17 April 2020

Selwyn District Council

**TRANSPORT REVIEW
PROPOSED Z ENERGY SERVICE STATION
RC205094 – 2 BROOKSIDE ROAD, ROLLESTON**

Figure 1: Additional Z Store Mobility Space

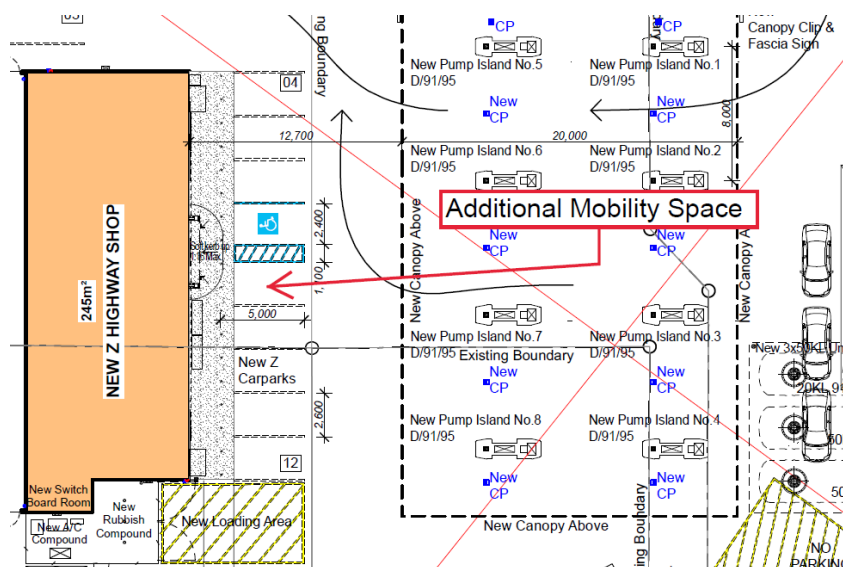
- 14. We also note that two mobility spaces are required to comply with District Plan and Building Code requirements. The ITA correctly identifies that the space illustrated in **Figure 1** could be marked as a mobility space. We recommend a requirement to mark this as a mobility space as a condition of consent.

- b. The provision of an additional mobility space at the Z station (as outlined in paragraph 13);
 - c. Provision of cycle parking at the Rolly Inn building (paragraph 20);

Figure 2: Extract from AustRoads Guide to Traffic Management

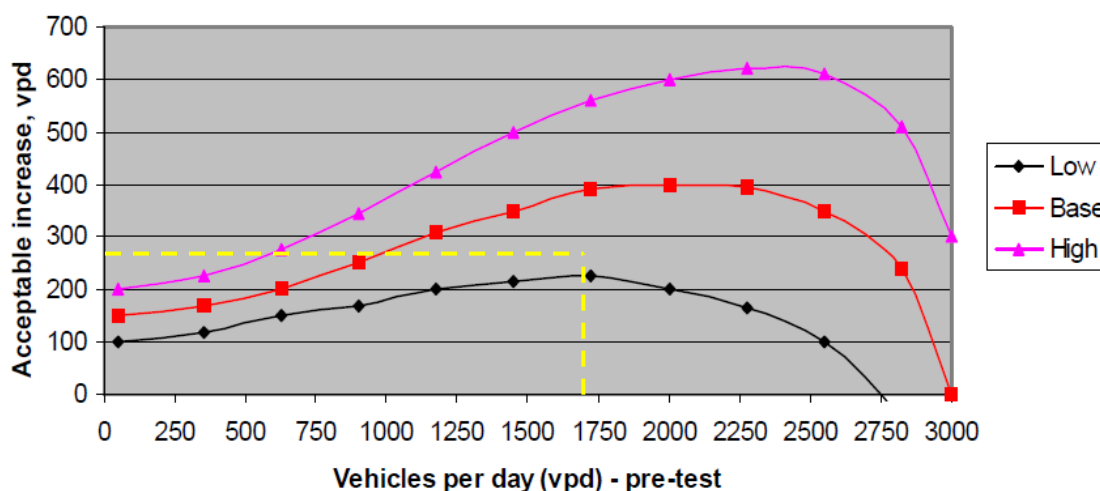
48. Whilst not directly applicable, guidance is provided in AustRoads *Guide to Traffic Management Part 8 – Local Area Traffic Management* as to when communities may notice increases in traffic volumes. **Figure 2** sets out the curve from the AustRoads guide.

49. The curve is presented as a range rather than a specific line because of errors and daily fluctuations in traffic volumes. Two supplementary lines are included (one for each side of the base line). An increase in traffic that occurs between the low curve and the base curve is *probably* acceptable. An increase between the base curve and the high curve is *possibly* acceptable. An increase that falls above the upper curve would *not* be acceptable.

50. The predicted increase in traffic associated with the proposed activity is between the lower and base curves (see yellow dash line in **Figure 2** below). Given this, the effects of this additional traffic volume on this road is probably acceptable as defined by this guide. However, it is emphasised that this information only forms part of the wider contextual analysis that considers the amenity effects on this road. Wider amenity related effects (for example, noise, vibration and glare etc.) might require input and/or assessment by others. From a traffic engineering perspective, the overall 'volume' increase is however considered to be within acceptable / tolerable limits.
